INNER WEST

DEVELOPMENT ASSESSMENT REPORT

Application No.	DA/2020/1094
Address	1 – 9 Thomas Street, Ashfield NSW 2131 (Also known as 2-6 Cavill Avenue)
Proposal	Demolition of all buildings; construction of a 10-storey mixed use development comprising: 3 storey basement car park with 320 spaces, ground floor retail, and 264 residential apartments.
Date of Lodgement	24 December 2020
Applicant	Shayher Alliance Pty Ltd
Owner	Shayher Alliance Pty Ltd
Number of Submissions	Initial: Five (5) After Renotification: Three (3)
Value of works	\$121,821,700.00
Reason for determination at Planning Panel	General development with a capital investment value over \$30 million
Main Issues	ADG non-compliance and non-compliance with clause 4.3 height of buildings under the ALEP 2013
Recommendation	Approved with Conditions
Attachment A	Recommended conditions of consent
Attachment B	Plans of proposed development
Attachment C	Clause 4.6 Exception to Development Standards

Figure 9: Building interface of 8-10 Cavil Avenue and the proposed Building D in section

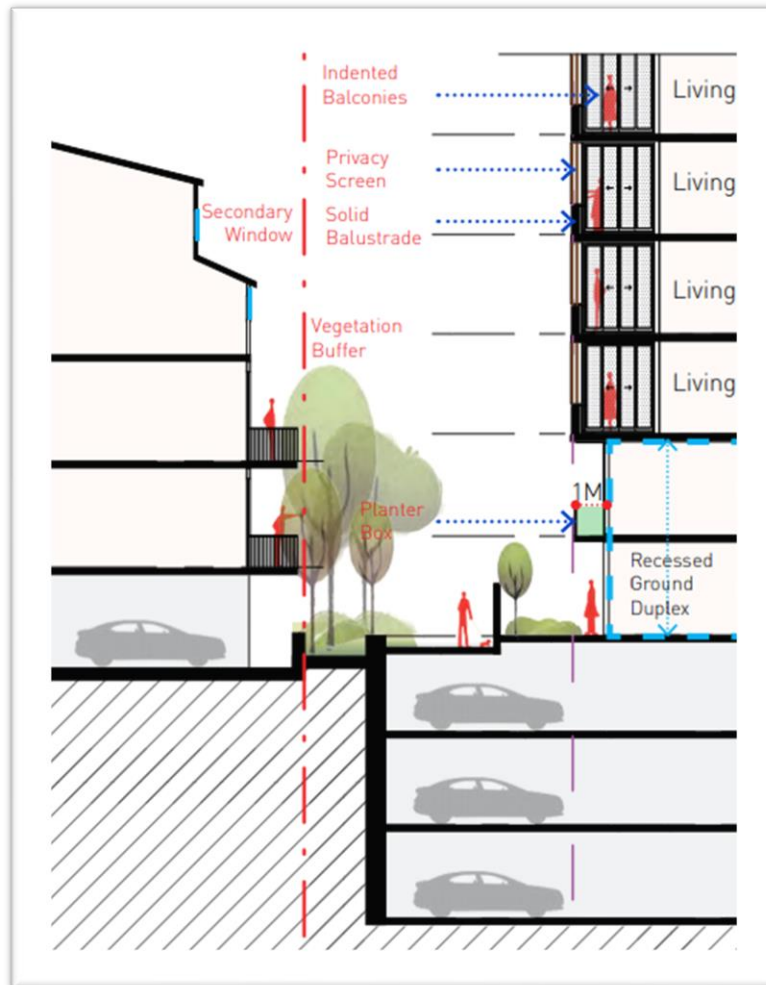
A review of the proposed Building D has confirmed that the levels 01 to 09 have each been designed to be setback 8m from the northern boundary of the site. Analysis of the neighbouring 8 - 10 Cavil Avenue has established that the existing neighbouring development has been designed to incorporate windows/openings and balconies along its southern (subject sites northern) boundary (as seen in figure 8 below). As such the current proposal's separation distances have been assessed as achieving separation via distance between habitable rooms and balconies. Levels 01 – 04 of the proposal are fully compliant with the ADG requirements for separation, while levels 05 to 08 results in a 1m variation and level 09 results in a 4m setback variation.

The intention of this control is to ensure adequate building separation distances between sites, to ensure that they are shared equitably to provide reasonable external/internal privacy, natural ventilation and sunlight. A review of the proposed northern elevation has highlighted numerous window openings and balconies for the proposed units. As seen within figure 9 below these objectives have been actively considered and designed into the proposed development. The applicant has actively sought to design the proposed building D to not align with the existing floor levels of the neighbouring site and incorporated privacy measures

The proposed 4m setback variation relating to level 09 of Building D, privacy impacts from this level are minimal, with future residents obtaining a view over the top of the existing development. While views downward into neighbouring sites are obscured by balustrades and other solid elements. The proposed variation to level 09 is not expected to hinder the potential re-development of 8 – 10 Cavil Avenue, with the site providing its own opportunities for unit orientation directed to the northerly aspect where the highest degree of amenity would be achieved. The current proposal is considered to find an appropriate balance between resident/occupant amenity, while also attempting to limit overlooking and protect privacy. The proposed variation to the minimum separation distances is recommended for support.

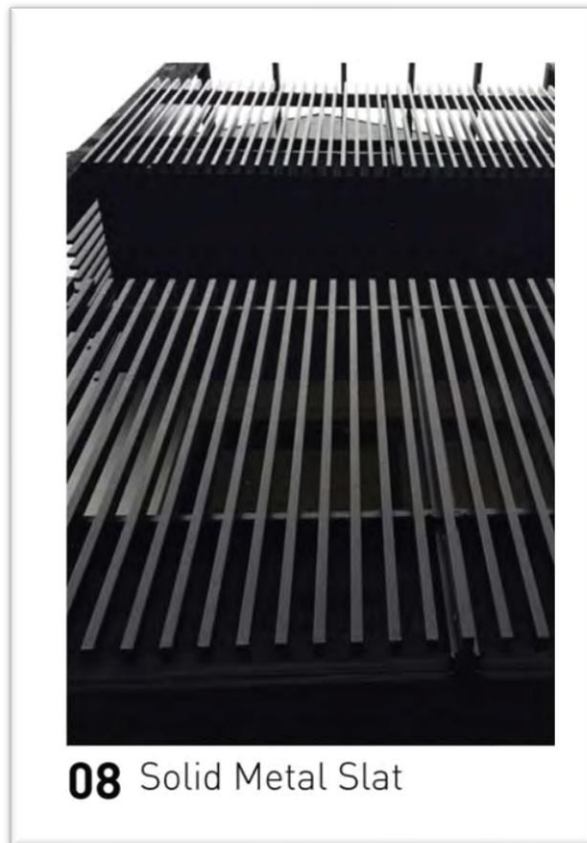
As outlined above the western boundary of the site is adjoining the R2 Low Density Residential Zone, which forms The Avenue. As such elements of the development located along the western boundary are required to be setback an additional 3m. The proposal has been designed so that Building C addresses the western boundary interface. Building C has a maximum height of roughly 23m, has been designed over 6-7 residential levels and incorporates a 9m setback from the Western Boundary. This building shares a boundary with a number of residential properties along The Avenue and as such has been assessed against the provisions for separation between habitable rooms and balconies. With regards to Building C Levels 01 – 04 of the proposal are fully compliant with the ADG requirements for separation, while levels 05 to 07 results in a 3m variation. The western elevation of Building C relates largely to living room windows and balconies for units.

The intention of this control is to ensure adequate building separation distances between sites, to ensure that they are shared equitably to provide reasonable external/internal privacy, natural ventilation and sunlight. To protect privacy for neighbouring residents and future occupants the applicant incorporated several privacy treatments including:

- Ground Floor vegetation screening
- Increased windowsill heights to primary living room windows
- Introduction of planter boxes to external edge of living room windows (level 1 units)

These treatments have been designed to minimise the potential for direct sightlines when viewed from a horizontal plane (seated or standing) and when looking down from an elevated position. These privacy measures when combined with the proposed 9m setback are anticipated to ensure a sufficient level of amenity and privacy for all residents. In this instance privacy impacts will have the greatest impact from levels 01 – 03 as they are on similar floor levels as neighbouring residential developments. These levels are fully compliant with ADG separation requirements and will be appropriately treated with the measures listed above. With regards to levels 05 – 07 (levels which result in the proposed variation) they are situated to be above the roofline of neighbouring residential units in the avenue and incorporate sufficient measures (listed above) to ensure minimal opportunities for occupants to obtain sightlines downwards. Due to the site's location to the east of properties located within The Avenue impacts of overshadowing are expected to be minimal and not substantially improved by strict compliance with the ADG setback controls.

Figure 11: Proposed separation distances between buildings B-C on levels 02 – 04

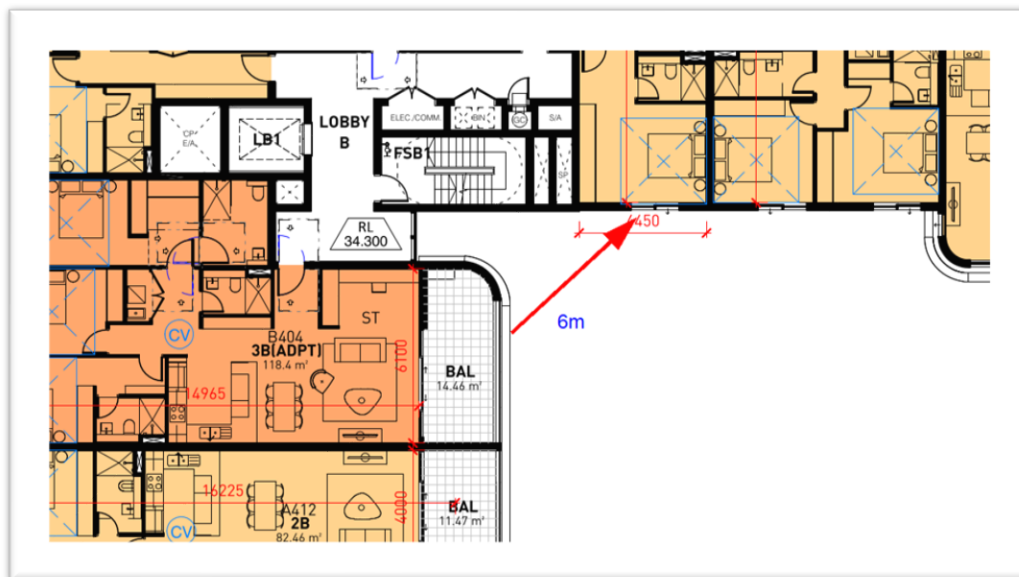
A review of the proposed levels 05 to 06 has highlighted the same separation variation to Buildings B-C & C-D outlined above under figures 11 and 12. This continuance of a variation is largely resultant to the employment of similar floor plans upon these levels. Under the ADG these elements of the development are required to be separated by 18m. Given the size and shape of the subject site, strict compliance with such separation distances is unreasonable and would limit the development potential of the site. In response to the proposed variation the applicant has employed similar privacy treatments discussed above. These privacy treatments are again suitably employed to avoid substantial privacy impacts and will ensure a high degree of amenity for all occupants. The proposed variation is therefore again recommended for support.

Figure 15: 30m Height Blanket, detailing elements which protrude beyond the maximum height limit.

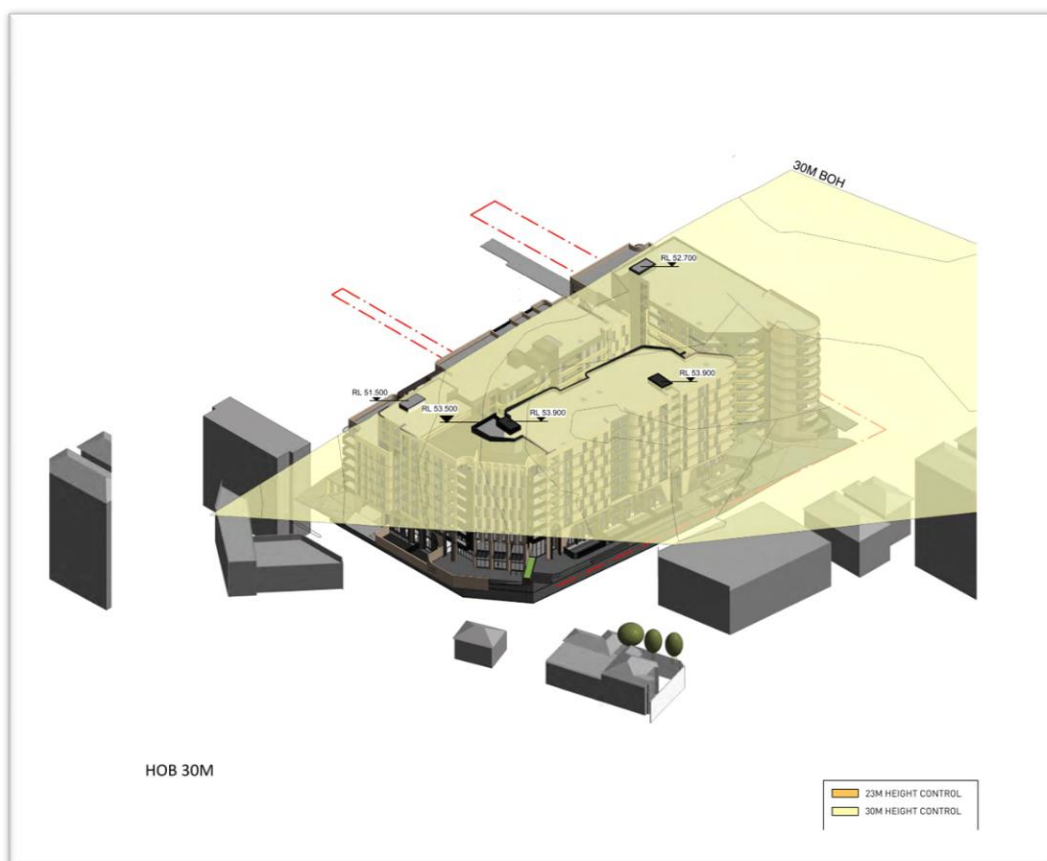
The subject site meets the requirements of clause 4.3(A) and as such the *land* on which the development is proposed is now permitted to achieve a maximum building height of 30m. As seen within figure 15 below and LEP compliance table above the buildings A, B & D propose minor variations to this maximum 30m height limit. Building A incorporates the highest variation of 1.2m (4%).

The applicant seeks a variation to the Height of Buildings development standard under Clause 4.3 of the *ALEP 2013* by 4% (1.2 metres).

The applicant's written rational adequately demonstrates compliance with the development standard is unreasonable / unnecessary in the circumstances of the case, and that there are sufficient environmental planning grounds to justify contravening the development standard.

Figure 16: Highlighting single lane driveway exit providing vehicular access from/to Cavil Avenue.

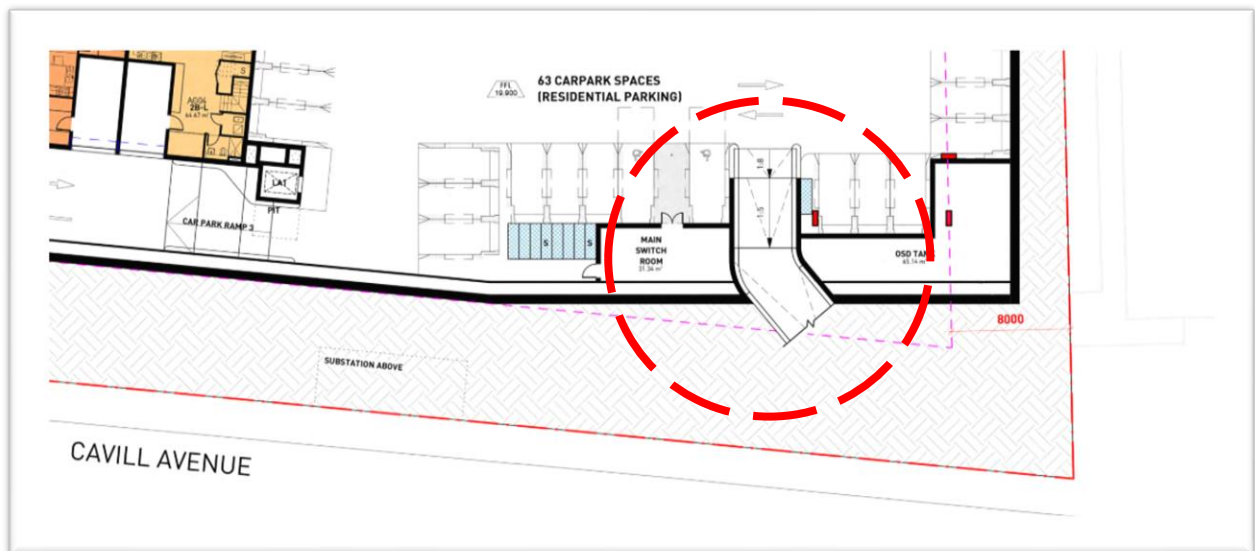
Alternative access (depending on the time of day) will also be provided via a single driveway from Cavil Avenue, as seen within figure 16 below. As part of the provided traffic assessment report the applicant has outlined that the Cavil Avenue driveway will utilise variable message signs (VMS) to manage uni-directional traffic flows. Examples of this signage are outlined below within figure 17. The applicant has advised that the changeover times for direction of travel on this driveway is to remain consistent so not to confuse residents and is to reflect timings of significant egress and ingress movements by residents. The suggested timings are as follows:

It is recommended that the owners corporation/strata management team be ultimately responsible for the management and determination of change over timings, allowing for reviews and modifications based on resident movements. This driveway is to be configured as to only allow residents living at the development access, with visitors to the development required to ingress and egress via the Thomas Street driveway. The proposed driveway arrangements (both Thomas Street and Cavil Avenue) have been reviewed by Council's Development and Traffic Engineers, who outlined no objections, subject to suitable conditions of consent. The proposed driveway arrangements are acceptable and recommended for support.

Figure 20: Driveway wall along western elevation which currently incorporates minimal visual interest

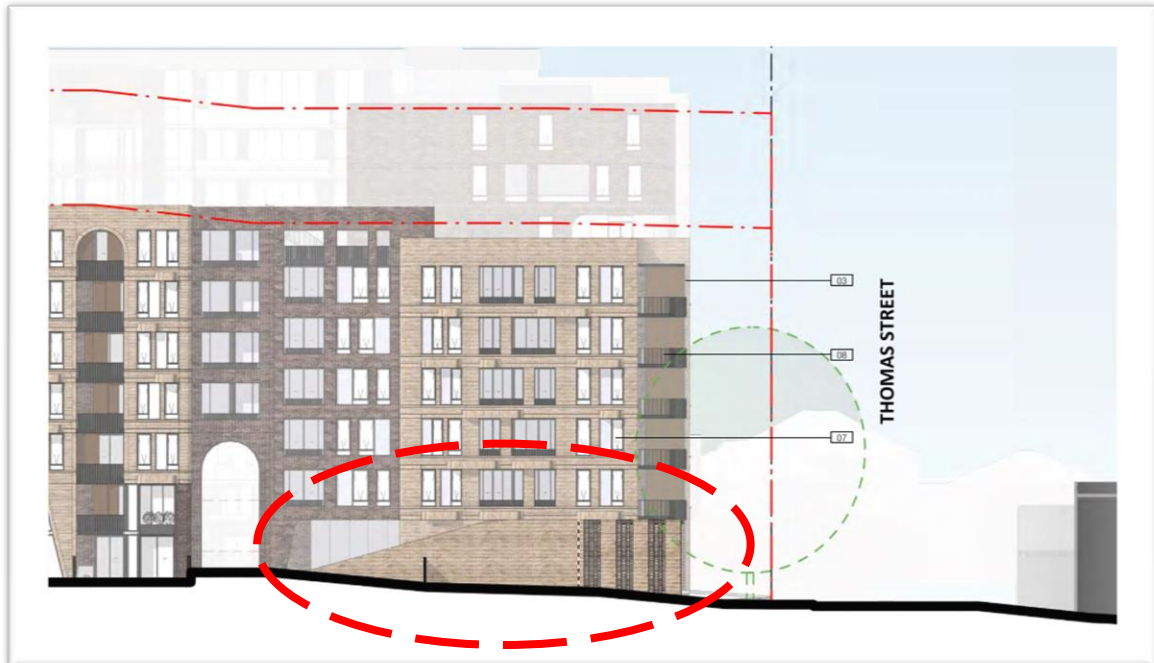
During assessment, it was noted that the driveway entry presents a large blank wall to the western elevation/boundary and adjoining pedestrian link. This wall achieves a height of 4.1m and while incorporating articulation near the Thomas Street frontage becomes blank when moving north further into the site. This wall is best illustrated through figure 20 below.

Concerns regarding the treatment of this wall and avoidance of a blank presentation which may be graffitied were outlined to the applicant on the 3/6/2021. At this time Council outlined their intent to impose a design change condition and requested feedback from the applicant regarding what treatments would be appropriate to improve this presentation. In response the applicant has provided additional detail and measurements to the wall as seen in figure 21 below. The applicant has advised that 6.2m of the wall will have decorative brick, while the remaining 9.5m will have 'running pattern'. Council has reviewed this response and considers a reliance of decorative brick insufficient to provide articulation and avoid graffiti. Therefore, a

design change condition requiring the continuation of a 'running pattern' for the remainder of the 6.2m stretch of wall is recommended for the consent.
